THE CITY OF SAN DIEGO

Report to the Planning Commission

SUBJECT: 301 SPRUCE STREET, NEIGHBORHOOD DEVELOPMENT PERMIT, PROCESS TWO

PROJECT NUMBER: [1053621](#)

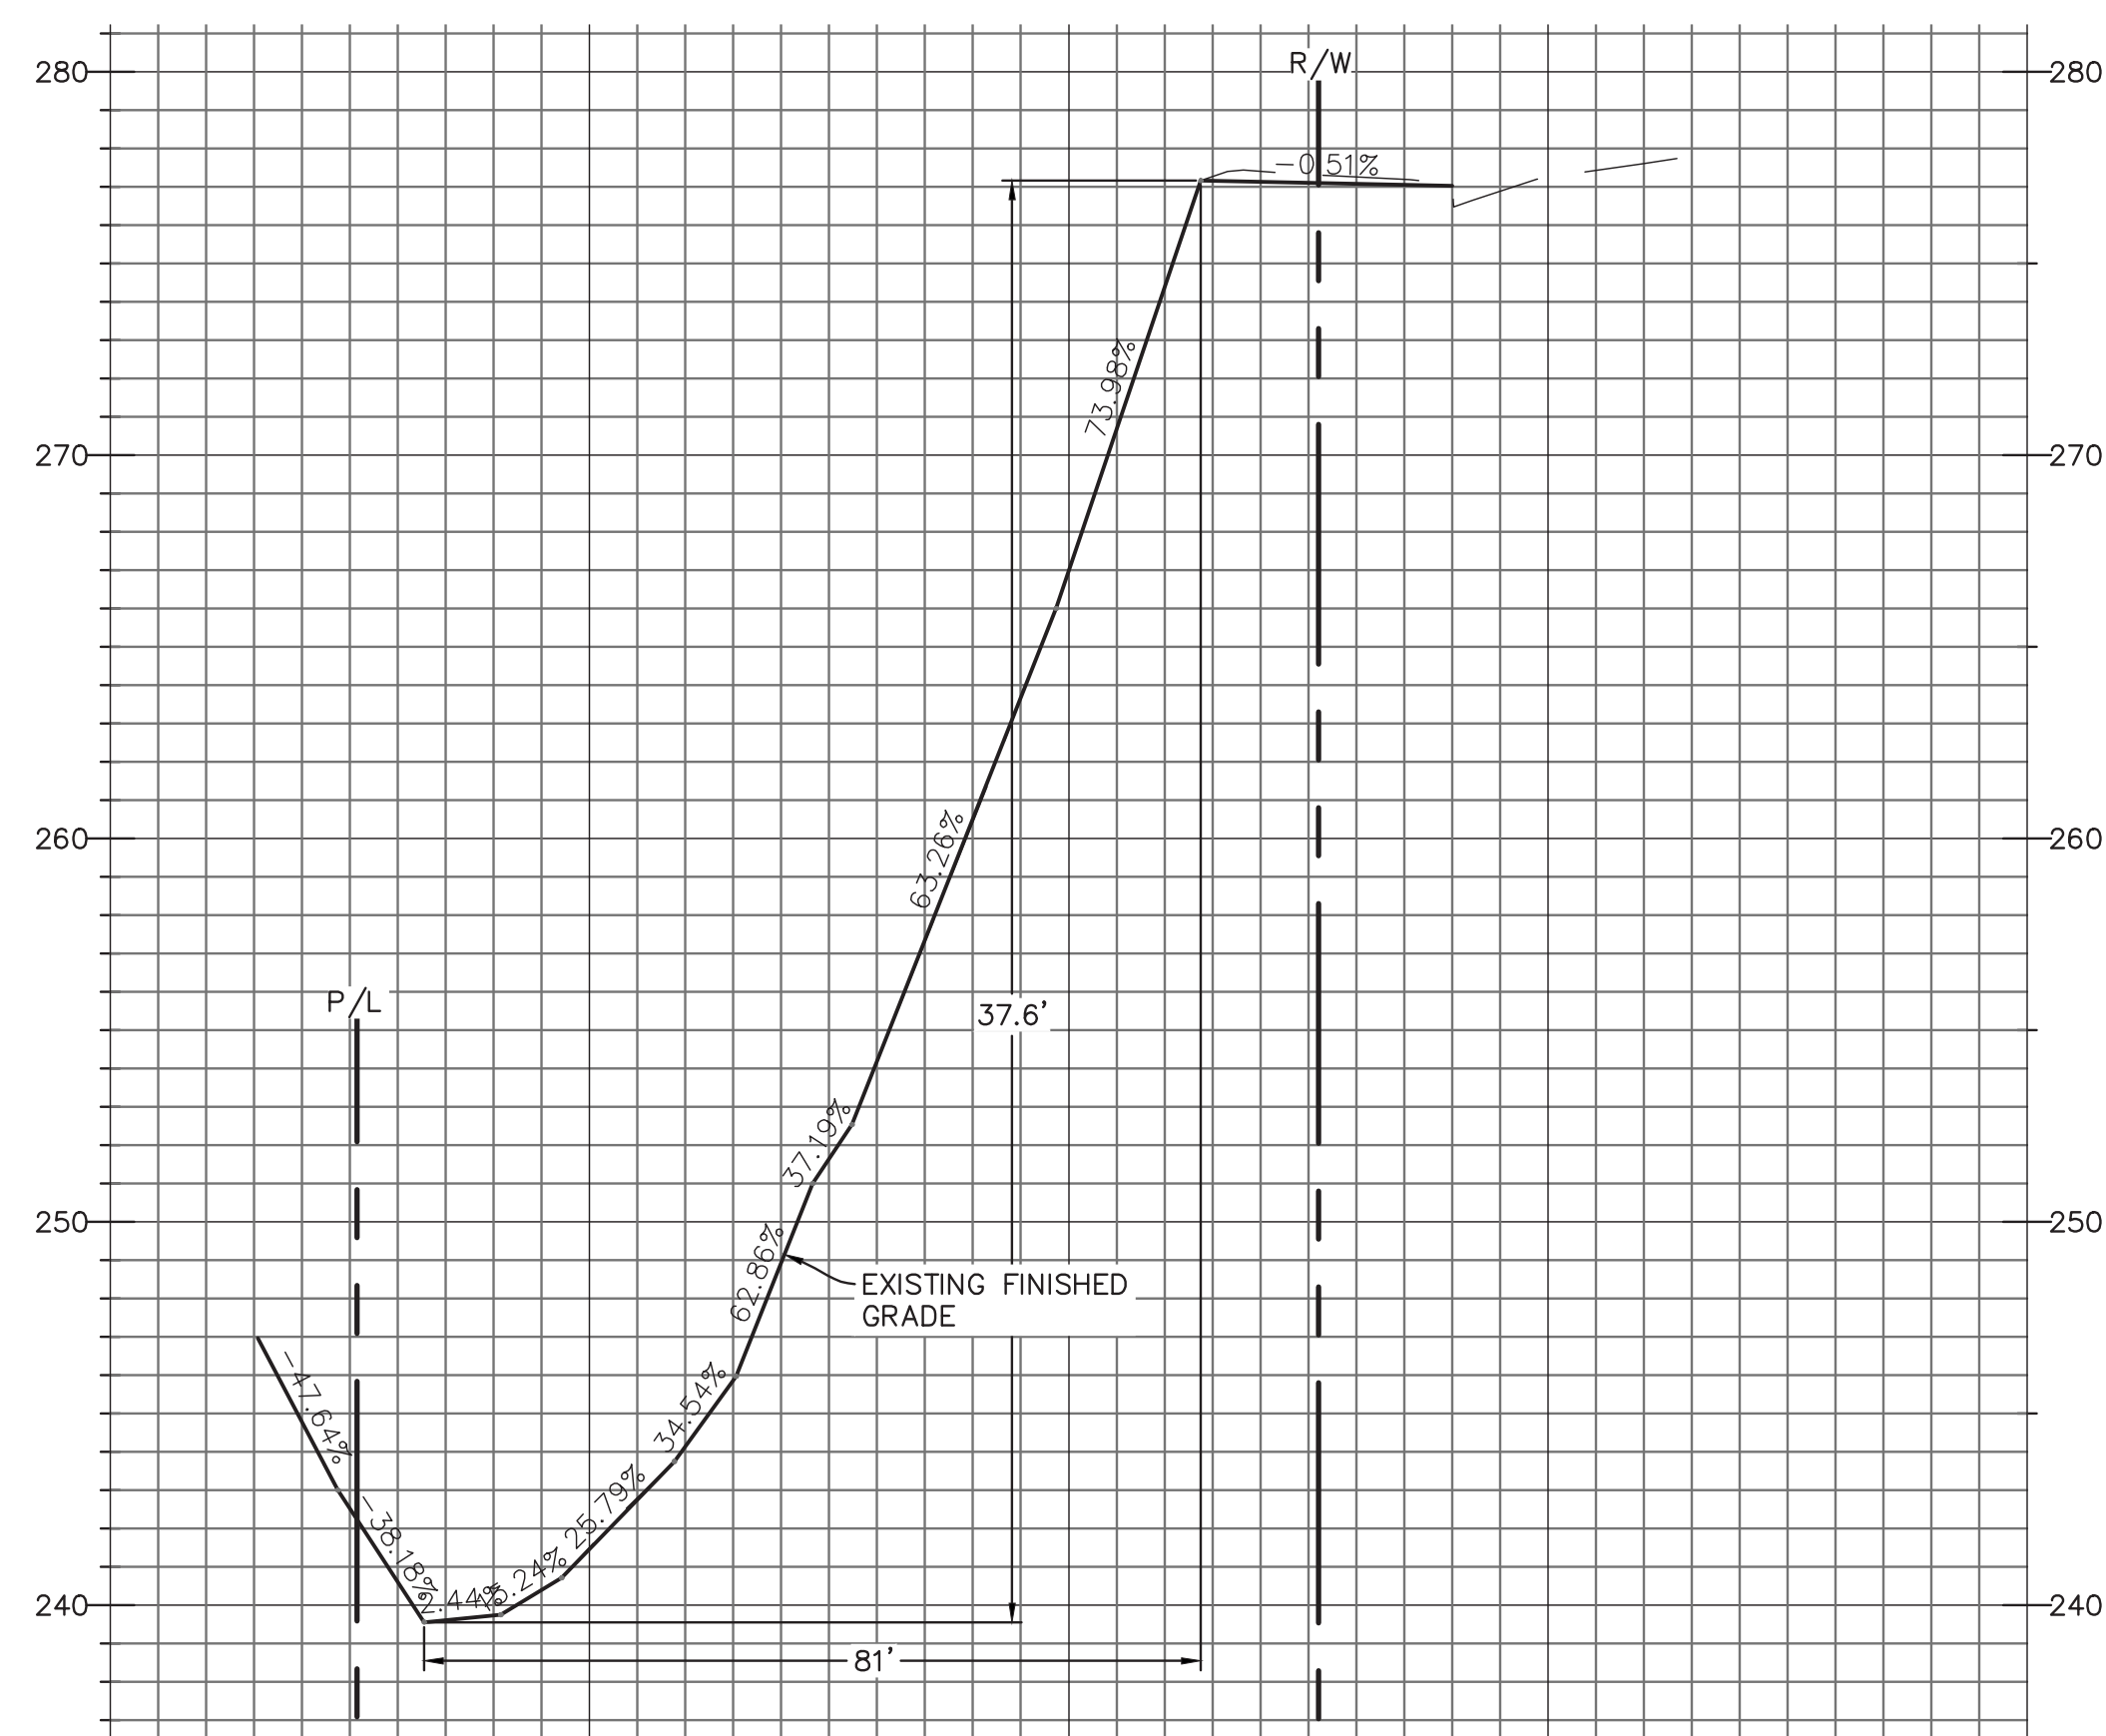
¹ Further, the City must confirm the Applicant's Slope Analysis with its own measurements. The Site Plan (Sheet C.0.04) claims the maximum vertical distance is 37.6 feet. Yet, the Project Geotechnical Report notes, "Site topography is nearly level with surface elevations ... ranging from approximately 282 to 278 feet above mean sea level...The subterranean parking level is at approximately 236 feet above mean sea level." That is a difference of 46 feet vertical elevation.

Civil added a note to Sheet C0.04 explaining that while the site contains slopes that are greater than 25%, those do not meet the city's definition of steep hillsides. Specifically, the slopes do not have a vertical elevation of at least 50 feet.¹

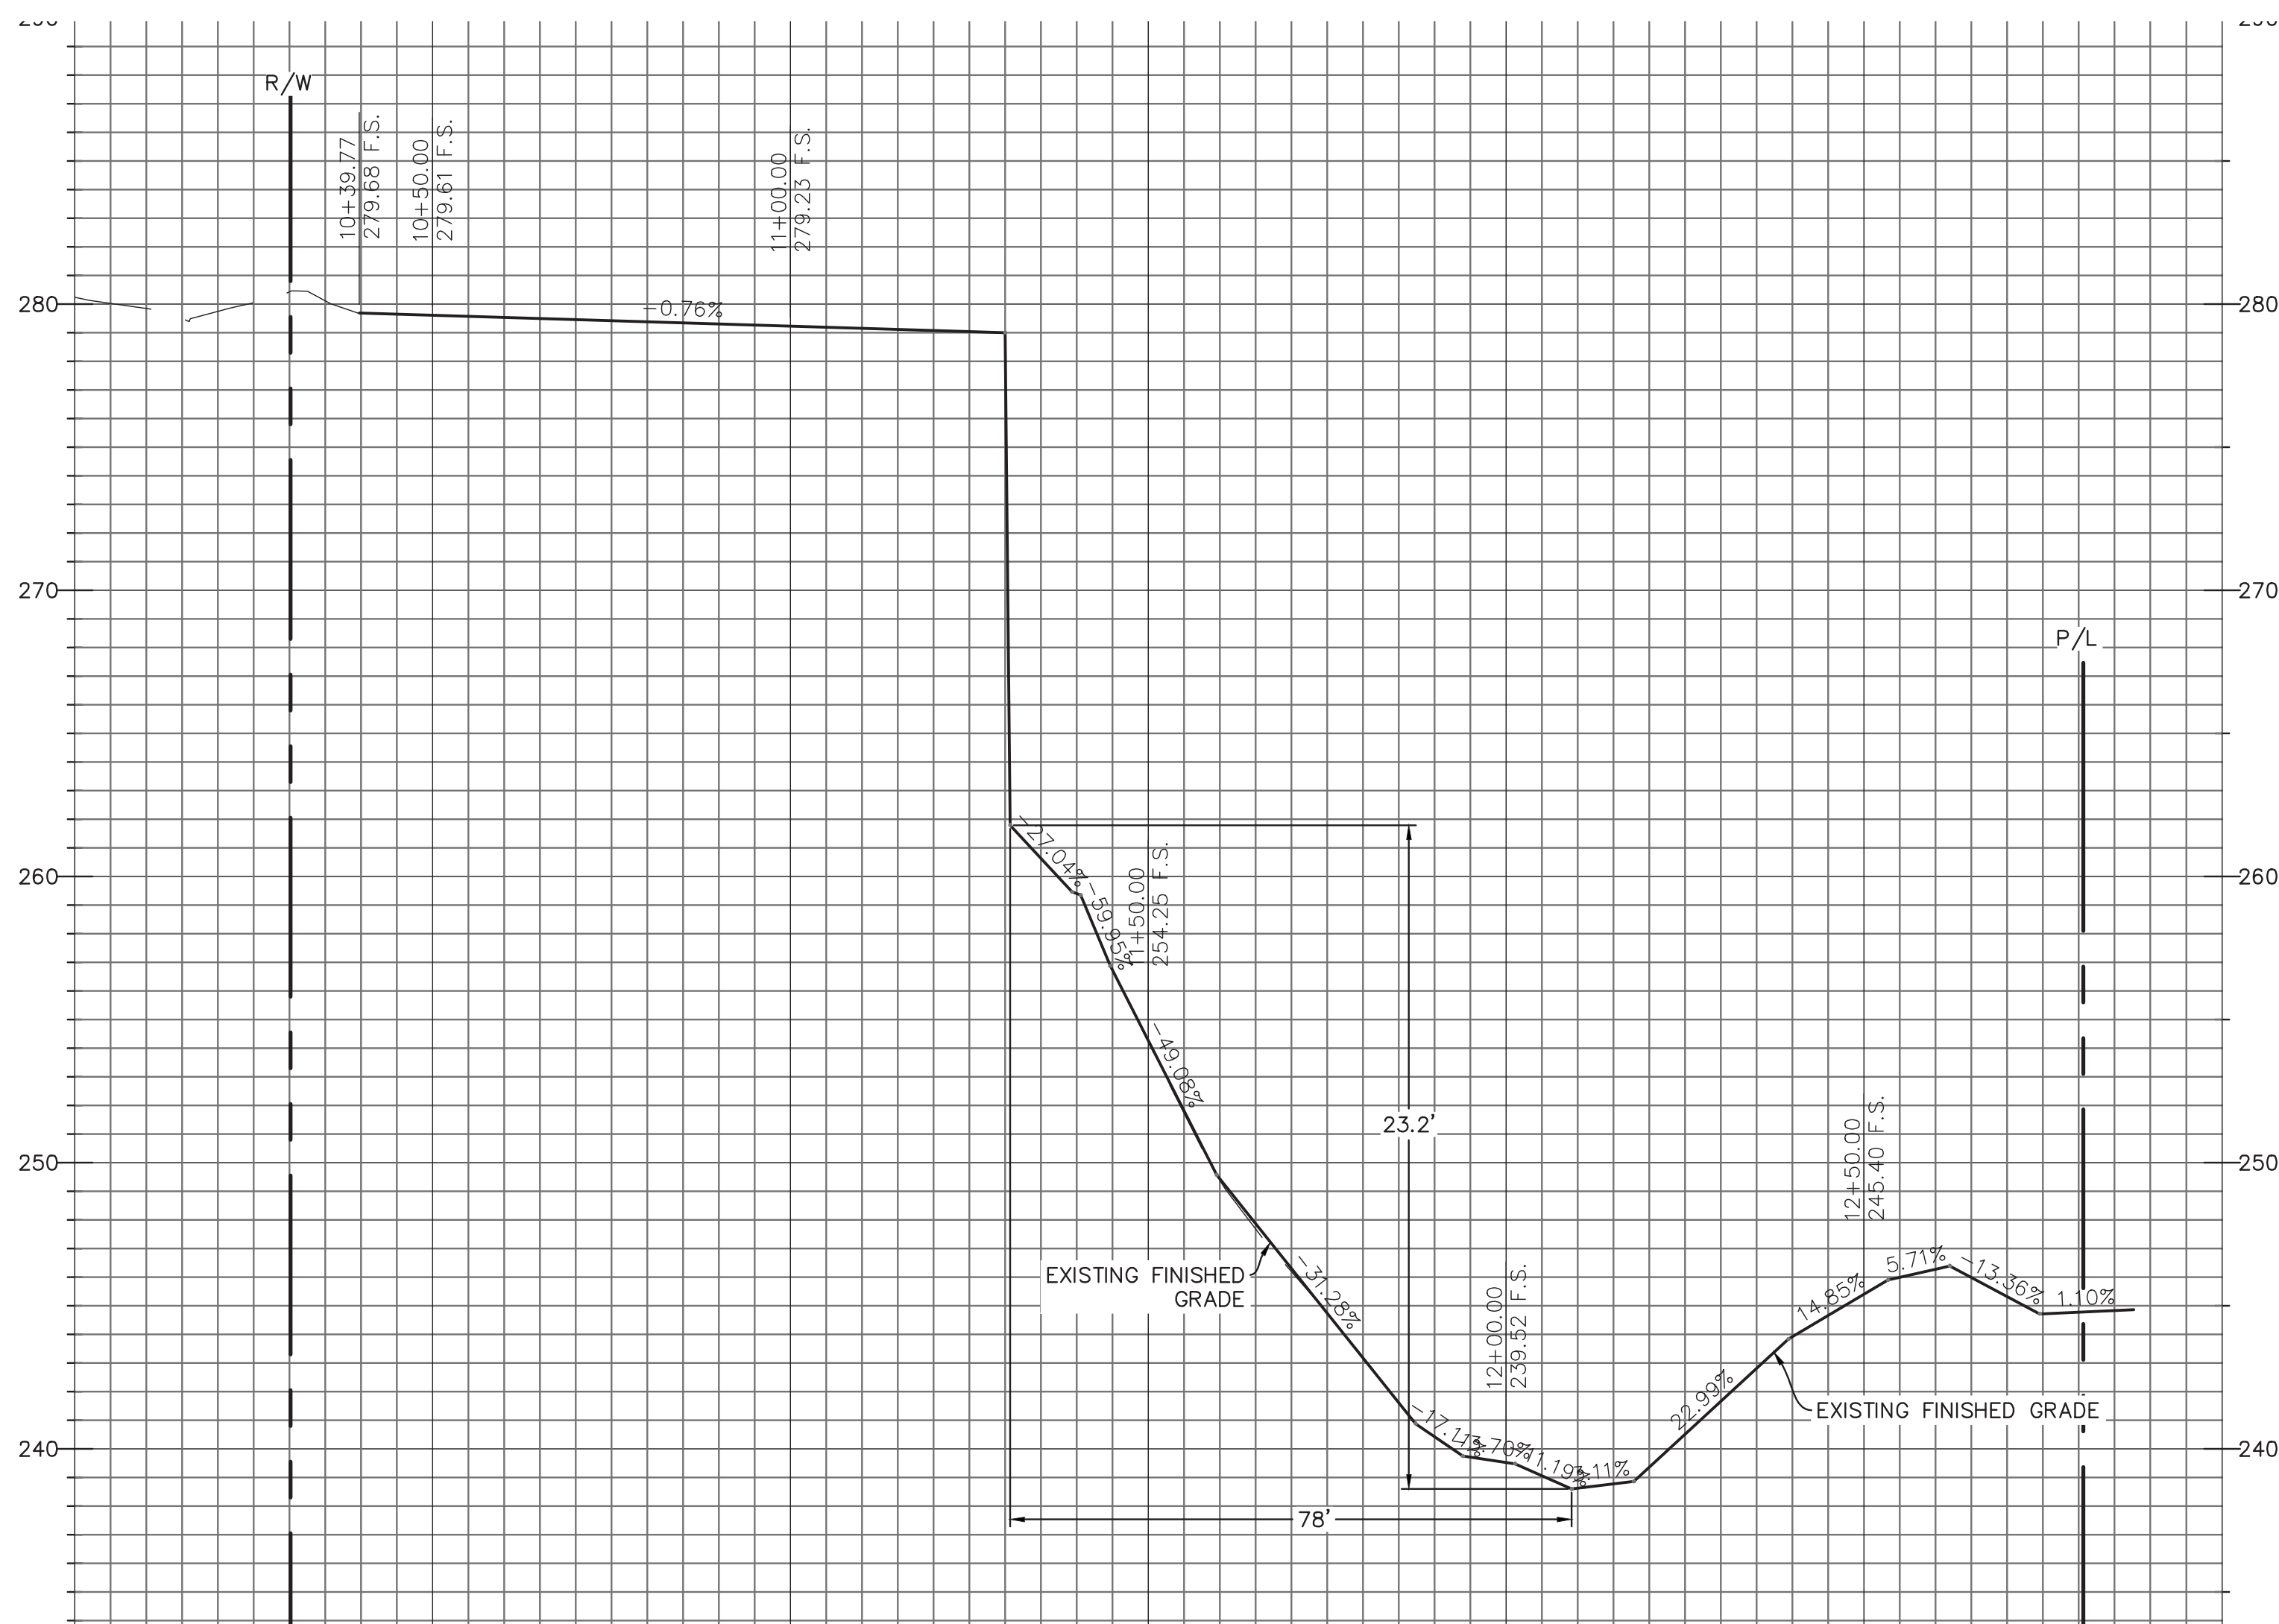
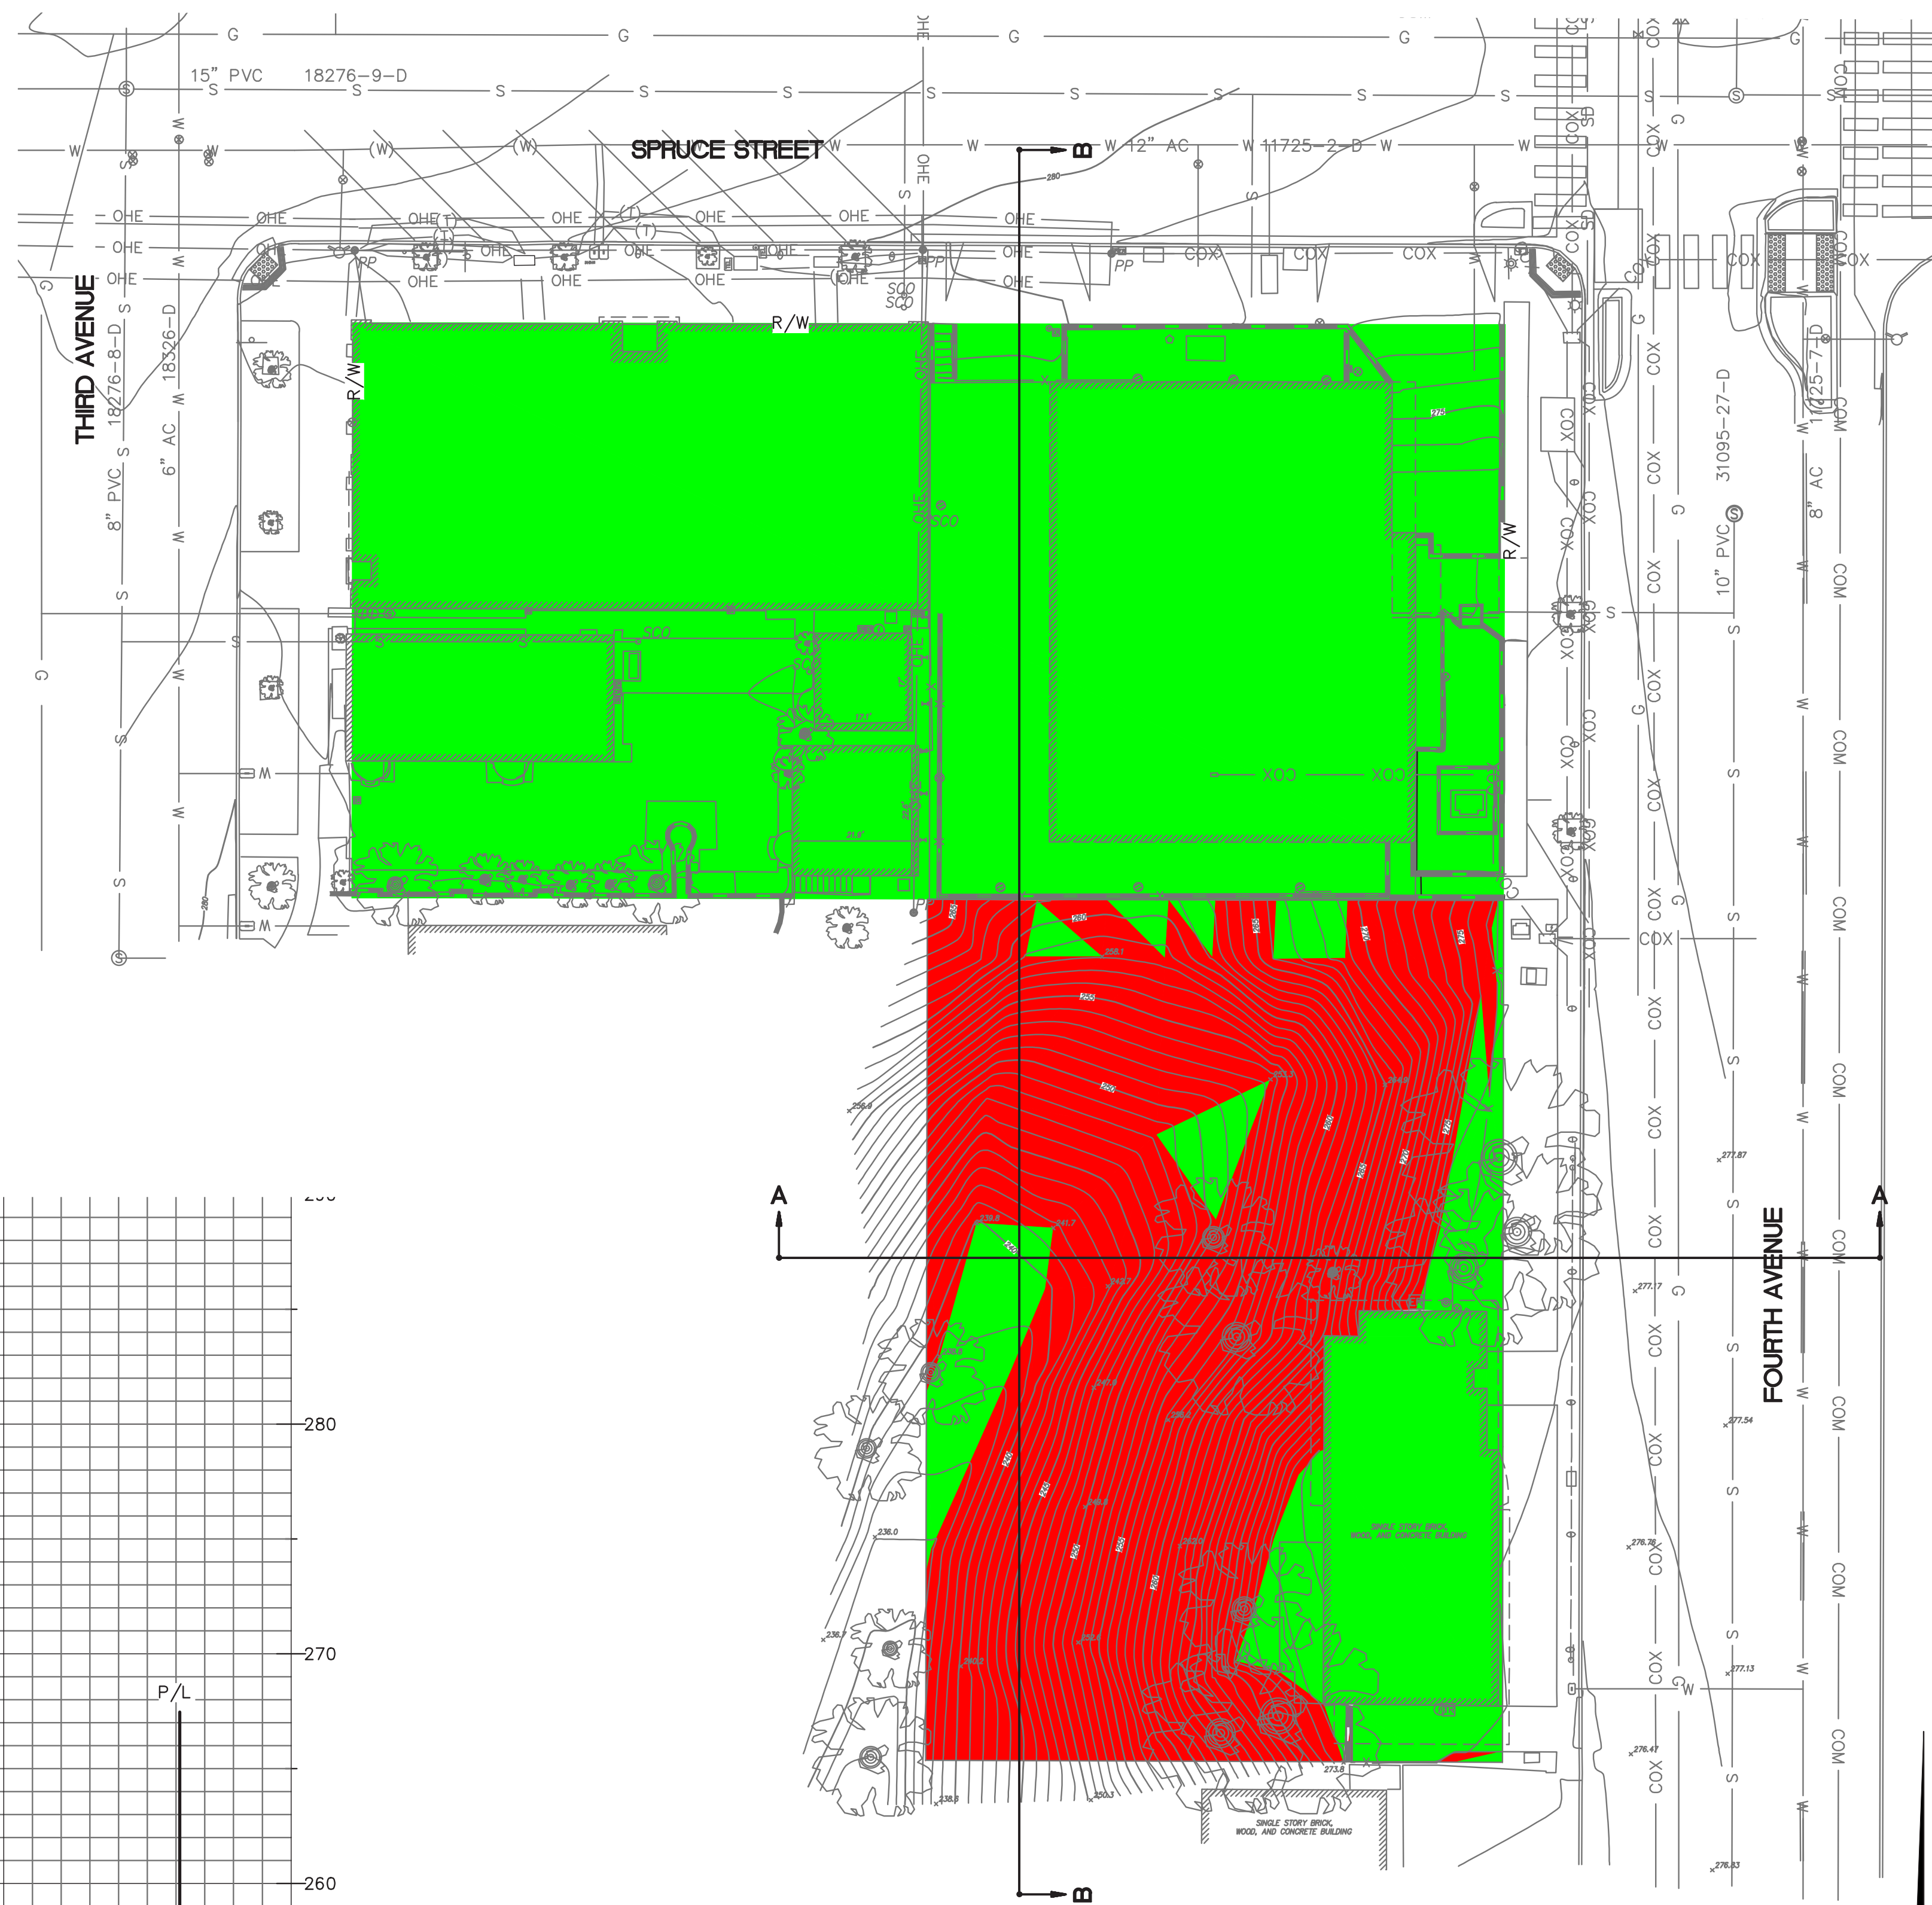
Sheet C0.01 of the plans appears to show nonconforming slopes per the San Diego Municipal Code 142.0133(c). Cut and fill slopes greater than 8 feet in height shall not exceed a gradient of 50 percent (2 horizontal feet to 1 vertical foot). Revise the plans to meet the City's slope gradient requirements.

Sheet C0.01 indicated “N/A” for “Retaining Wall Height” yet the Project’s Civil Sheets show several retaining walls planned. (*See, e.g.*, sheets A0.02, L2.11.) All walls must conform to the Steep Hillside guidelines.
